Title	Calisto Gantry Cover Bracket Inspection and Replacement
-------	--

Field Action

RXFA23-008, Rev A

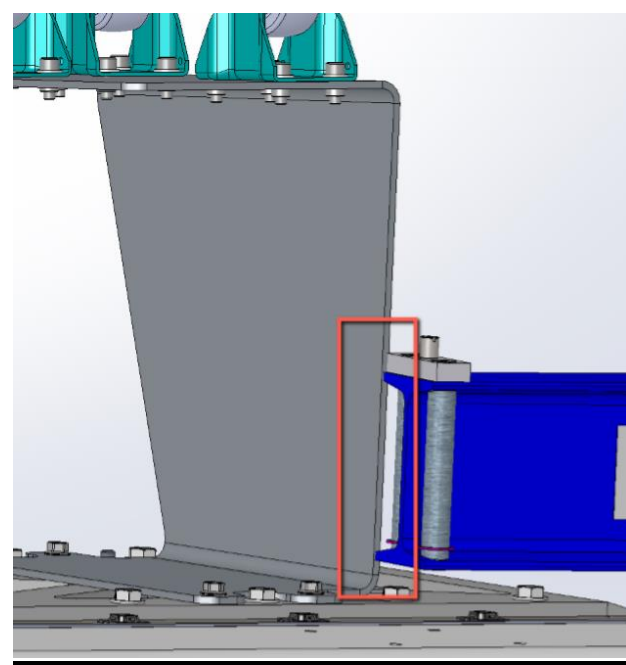
It has been discovered that when utilizing the Jib Crane Assembly while servicing Radixact systems with a Calisto style gantry, that in some instances there is not enough clearance for the Jib Crane to function as intended. In these instances, it will collide with the cover bracket at the top of the gantry. When this occurs, the Field Service Engineer may try to lift the Jib Crane to clear the bracket, which creates an unsafe working condition and presents a safety hazard to the Field Service Engineer.

6. Travel onsite and perform the Field Action.
7. Remove the gantry covers and inspect the Jib Crane and observe that the Jib Crane can move past the cover bracket at the top of the gantry without interference, as shown below.

This Field Action will have the Field Service Engineer inspect the Jib Crane to ensure that it has enough clearance to function properly and does not collide with the cover bracket. If it does collide with the cover bracket, a new cover bracket must be ordered and the existing cover bracket must be replaced.

8. If the Jib Crane does collide with the bracket, then order PN 1088370 - FRU, Enclosure, Gantry, Upper Roller Bracket, Radixact, Gen2.
9. Once the item has been received, replace it by downloading T-SVC-01348 – Upgrade the Radixact Gantry Enclosure Upper Bracket from Agile and replace the bracket.
10. Restore the system to functionality.
11. Close the work order in ServiceMax once the work has been completed. Please ensure that the signed Customer Notification from Step 3 is attached to the work order prior to work order closure.
